Prismatic guide units with forced return clamp and replaceable guide plates

Design According VDI 3357

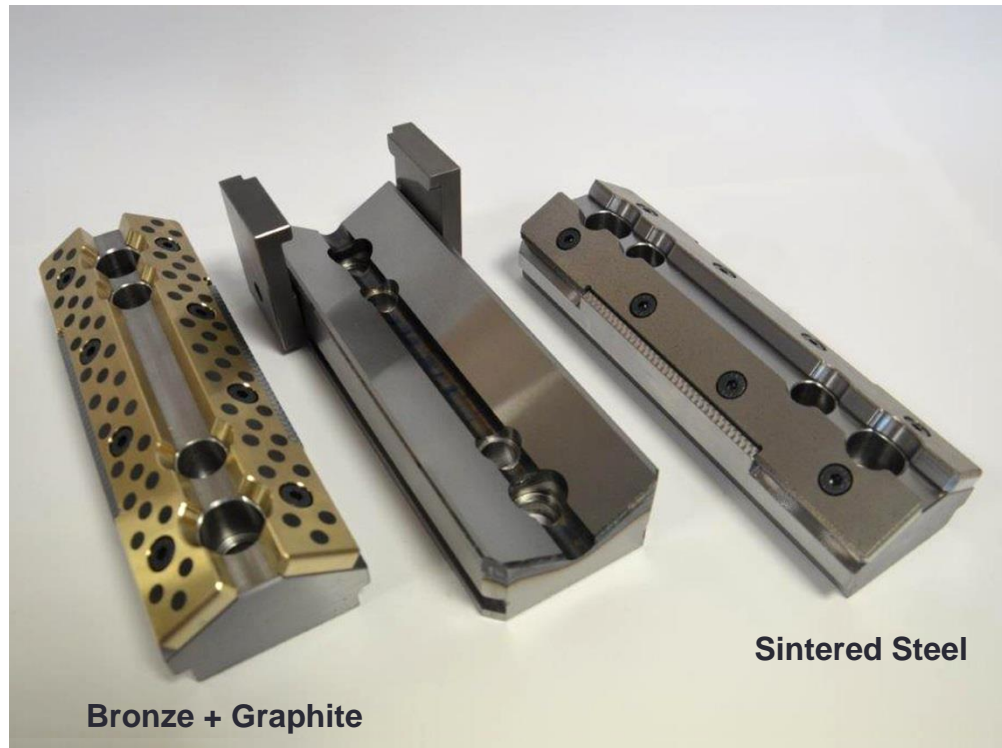
Thanks to a new design, the female and the male of the cam bottom V drivers with replaceable plates, are now exactly interchangeable with the VDI 3357 standard.

Now is possible to use the male with replaceable plates in pair with a standard female guide VDI 3357 and opposite.

In case of substitution of a standard male VDI 3357 in bronze graphite, without to change the full set, now is possible to use the GSB OILLESS male with replaceable plates, and more, is possible also to chose the sliding plates type.
